Amendments to the Drawings:

REMARKS/ARGUMENTS

ANNOTATED SHEET SHOWING CHANGES

FIG. 4

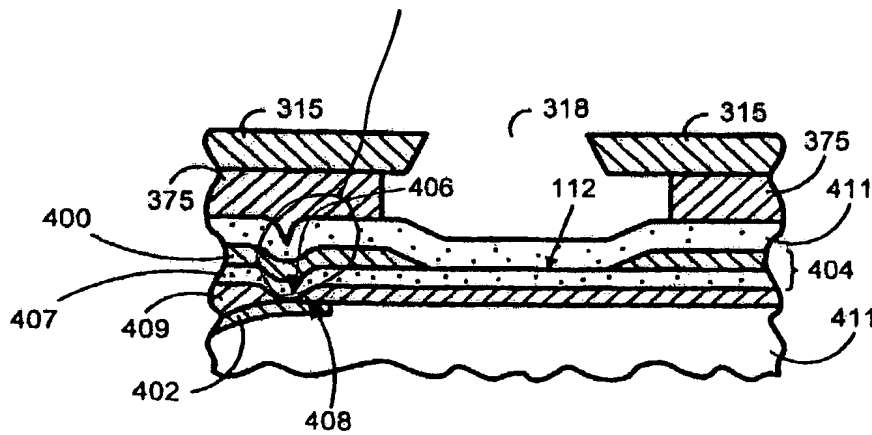
In FIG. 4, the lead line from reference number 406 is changed to more closely point to the via 406.

Arrow for ref. no. 406 lead line extended.
